Re: Seminole Electric Cooperative, Inc.
Seminole Generating Station, Putnam County Florida
Power Plant Certification No. PA 78-10
Post-Certification Amendment

Pursuant to Section 403.5113(1)(a), Florida Statutes and Rule 62-17.205, Florida Administrative Code, please accept this letter and attachments as a post-certification amendment to the Seminole Electric Cooperative, Inc. ("Seminole") Site Certification Application ("Application") for the Seminole Generating Station in Putnam County, Florida. This post-certification amendment addresses the installation of two (2) concrete pads within the Seminole Combined Cycle Facility (SCCF).

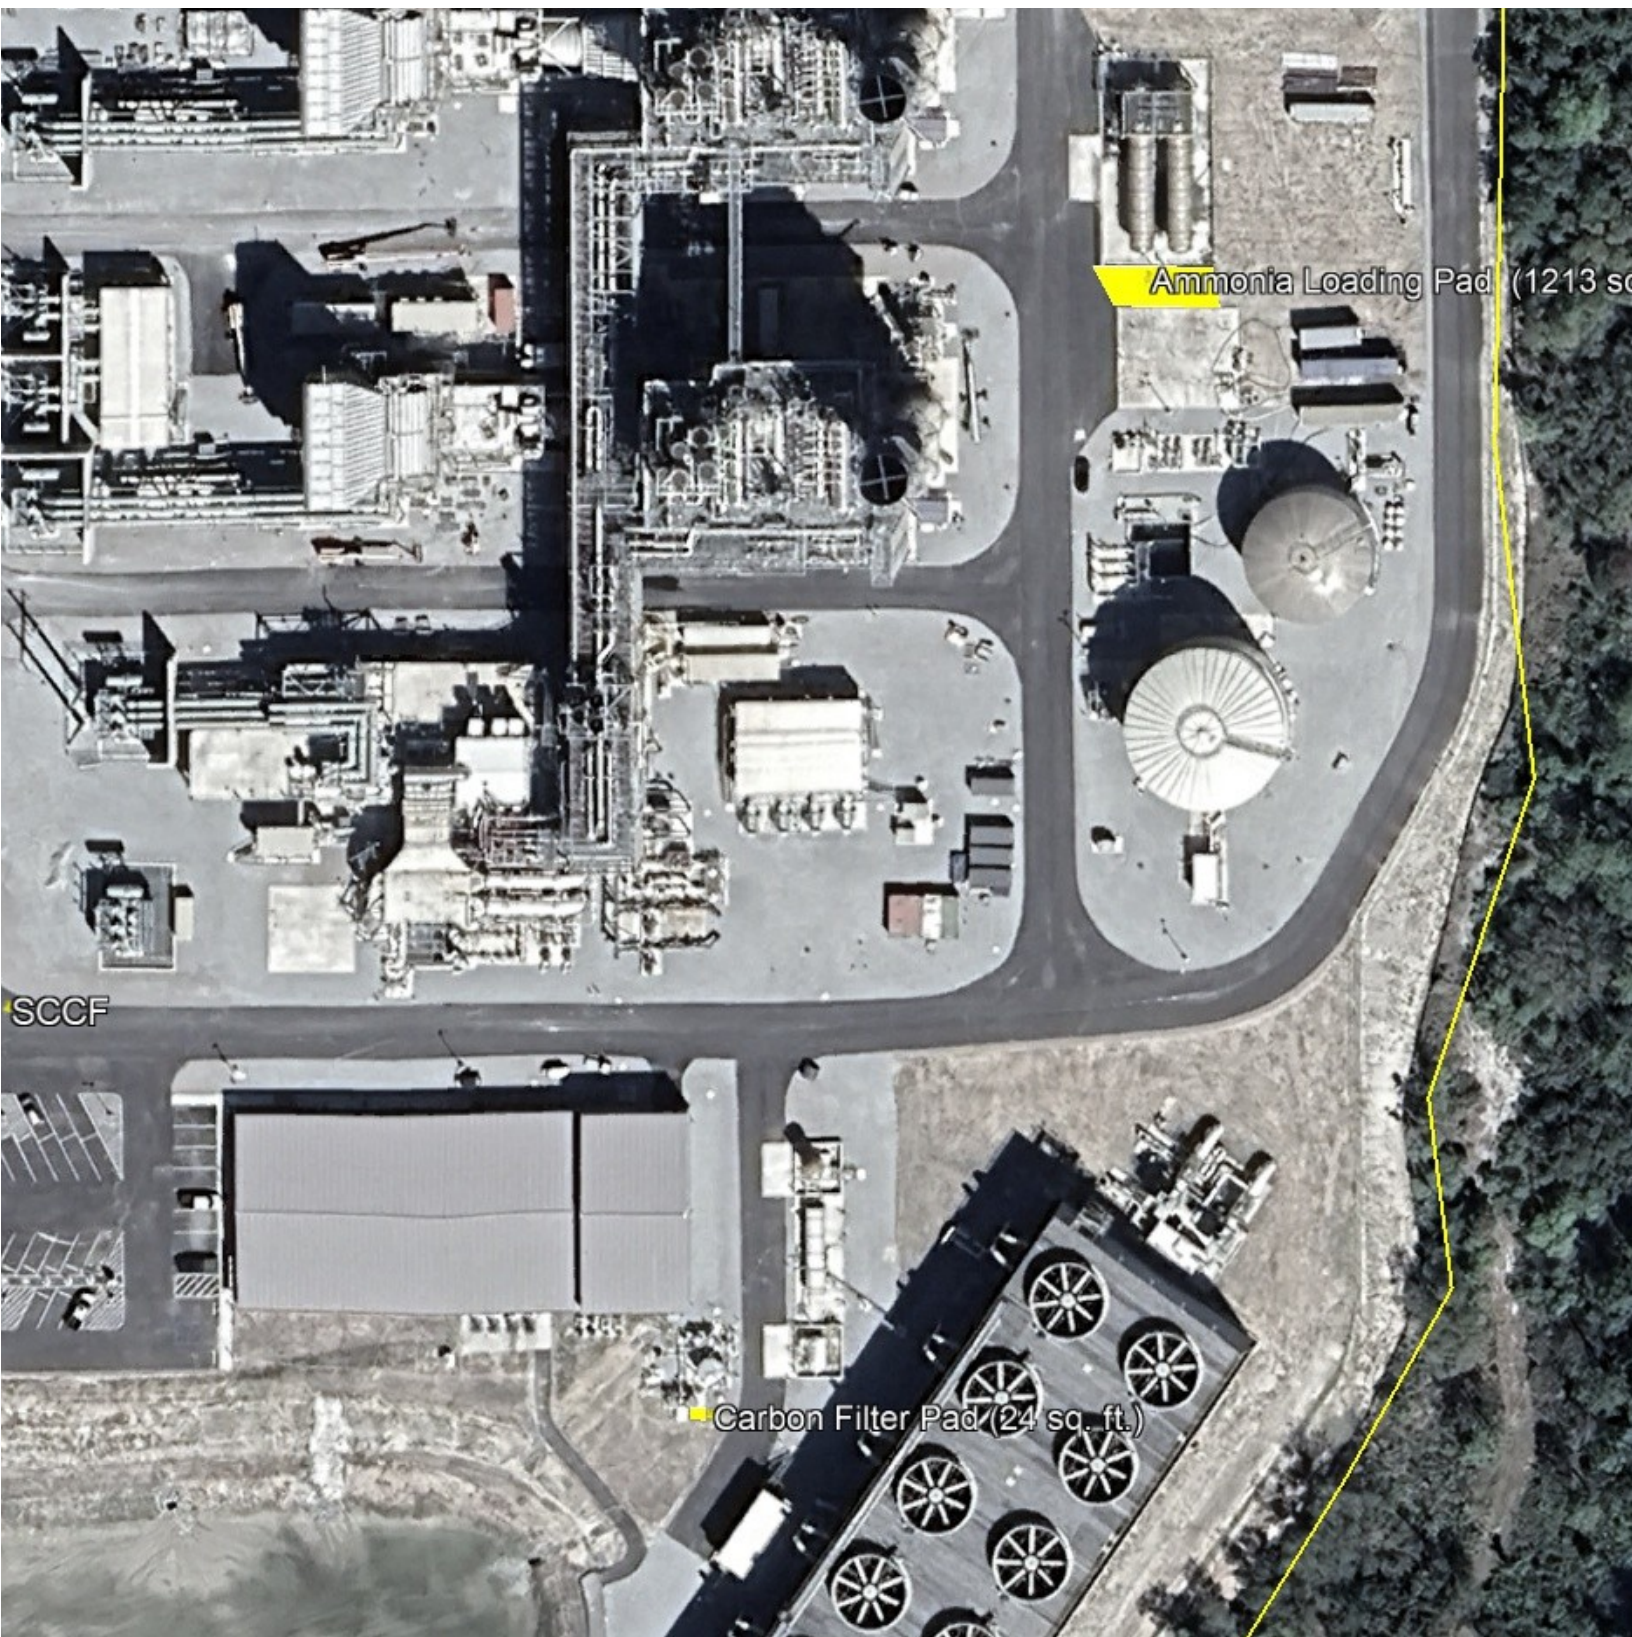
- (1) A 24 square foot concrete pad for installation of the potable water carbon filter. This pad will be located south of the administration building and adjacent to the existing potable water treatment system. Seminole provided notification of the installation of the carbon filtration system as a post certification amendment submitted November 22, 2024 (approved December 19, 2024).
- (2) An approximately 1200 square foot concrete pad immediately south of the ammonia storage tanks. This pad will provide a more stable surface to offload ammonia.

An aerial indicating the location of each of these pads is attached.
